PUBLIC UTILITIES COMMISSION

RE: Data Request Number 3. Regarding Need for Certain Portions of the Valley-Ivyglen Subtransmission Line and Fogarty Substation Project In Light of Alberhill System Project

Figure 1 Alternative System Configuration for Alberhill Project 11/10/09

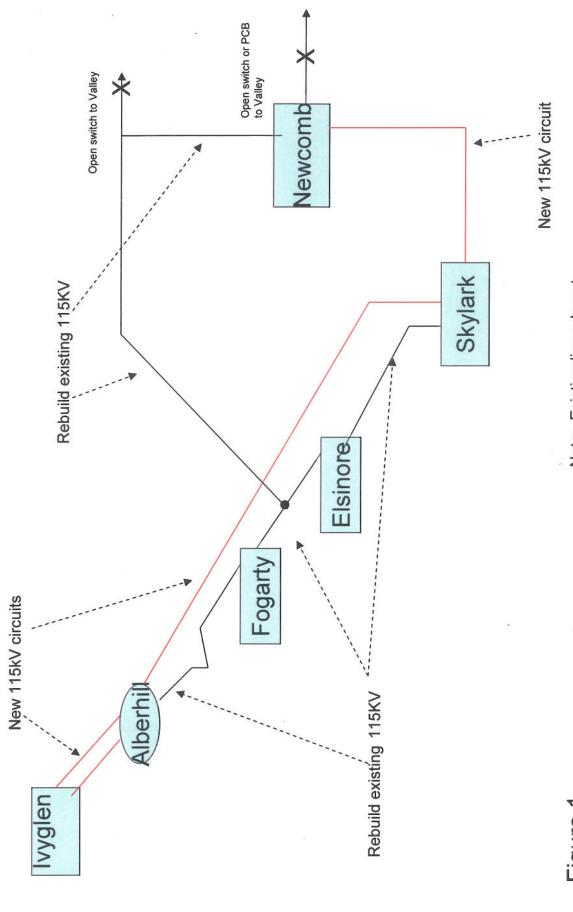
In an effort to identify a system that would minimize the above issues, the 115kV system configurations noted in the attached diagrams were developed. These configurations are designed to take advantage of existing lines and rights-of-way, rebuilding lines where required and limiting the need for new construction or right-of-way. The configuration in Figure 1 is one of a number of possible alternatives that could address the above issue. For example the "tap" point between Fogarty and Elsinore could be moved to the Alberhill - Skylark line, as noted in Figure 2. Or a fifth line from Alberhill to the tap point could be constructed, as in Figure 3. The common thread between these three alternatives is the elimination of at least the portion of the new Valley to Ivyglen line between the tap point and Valley, relying on the existing 115 kV line (rebuilt where necessary) for the connection back to one side of Newcomb.

The Commission requests that SCE perform necessary system studies (power flow, etc.) to determine if any of the above system configurations meet applicable reliability standards and a) document the system assumptions, b) report study results, and c) provide the Commission with its findings as to the feasibility regarding each system configuration.
